UPPER TRISHULI-1 HEP (216MW)

REVIEW NOTE

Contractor	**Doosan Heavy Industries & Construction Co., Ltd.**		
Title of the Document	Layout Drawing for Monitoring of Main Access Tunnel		
Document No.	UT1-C-845-CVL-DG-70007	Revision	0A
Date of Documents	05.01.2022	Received Date	09.01.2022
Transmittal Form No.	UT1-HEP-DHI-D-0113		
Previous Review Date/Status	N/A	Prev. Review Note No.	N/A
Review Note No.	**RN-0096**	**Present Review Date**	**26.03.2022**
		Present Review Status	**RR**

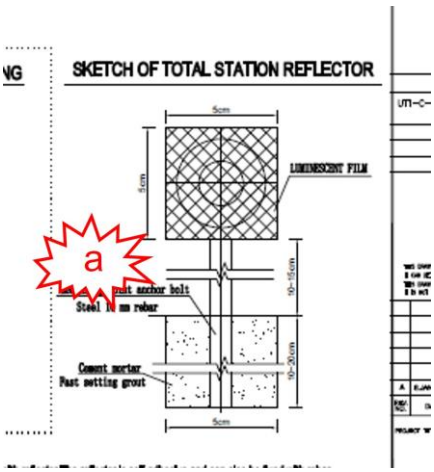
a) Distance between rock surface and target should be "max. 30 mm" and not "10 cm – 15 cm".

The tunnel encounters two junctions. Respective monitoring system shall be developed for both junctions for the individual construction stages of the junctions.
